Re: Land Adjacent to 29 Milton Park London N6 5QB – Application Ref:(HGY/2023/2691)
Our ref: ICE21.273.301.024
London, 28 November 2023

We refer to the objection dated 20 November 2023 from The Highgate Society.

Appendix 2 – Shading Studies

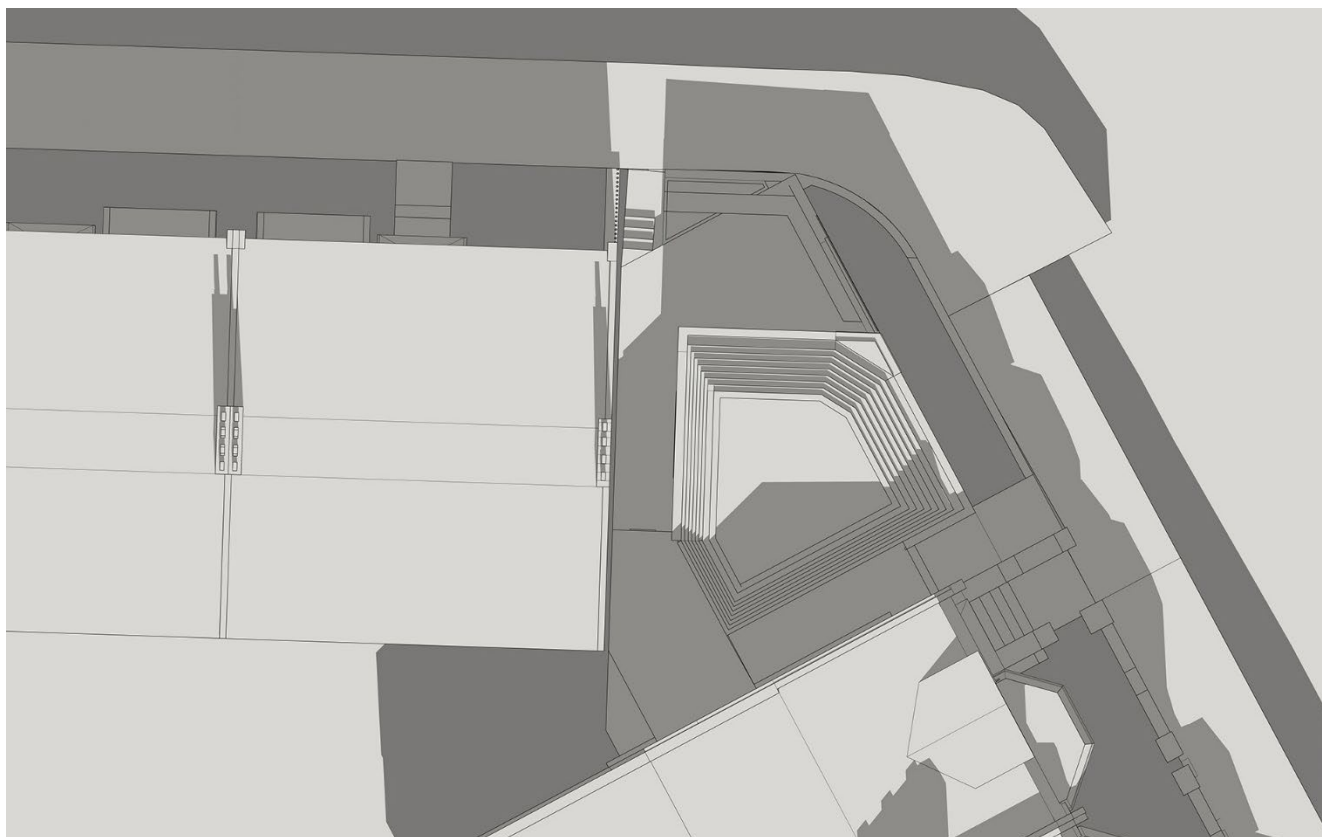
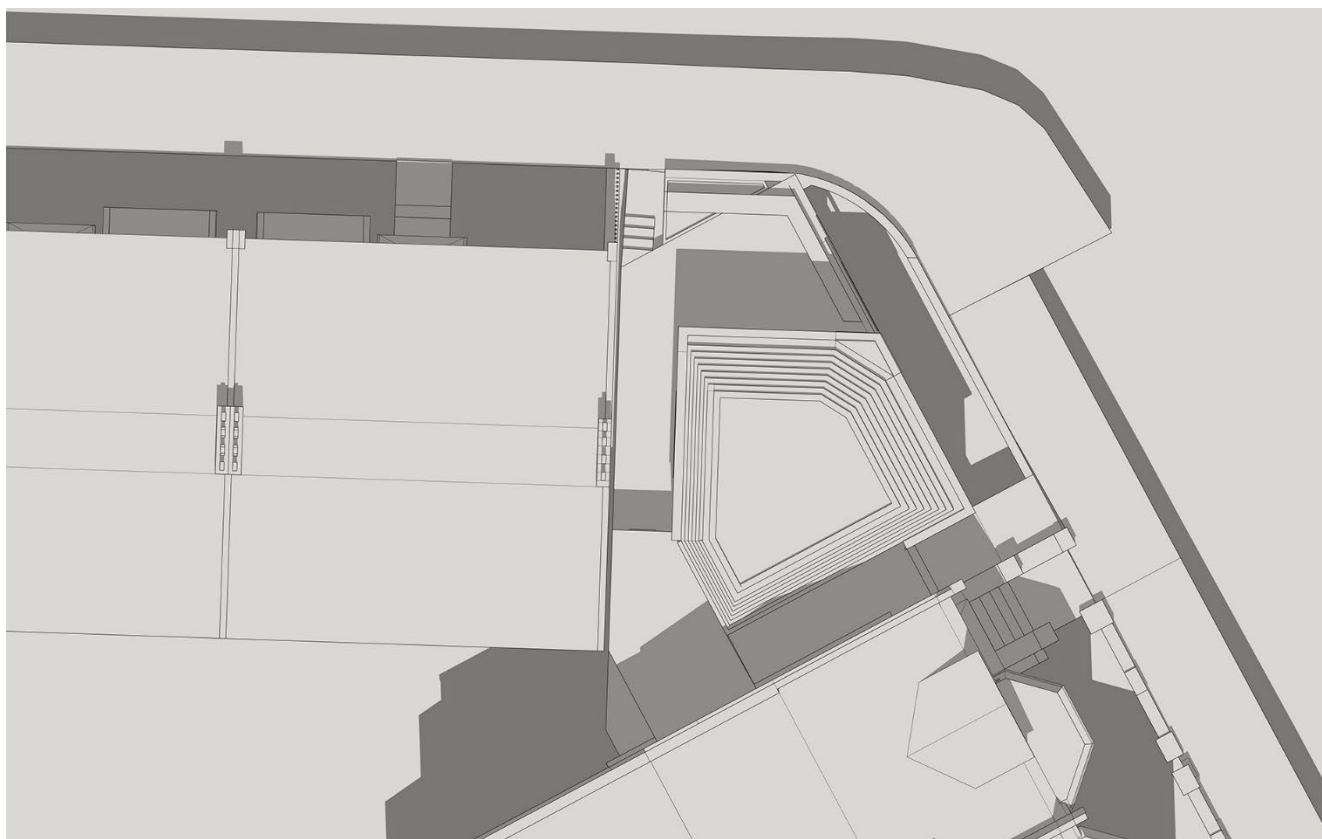
The attached revised sections PL2.11 and PL2.12 shows the location of the PVs with an upstand to prevent the units being visible from the street. Shading studies used to design the roof to allow the use of renewables are also attached at Appendix 2.
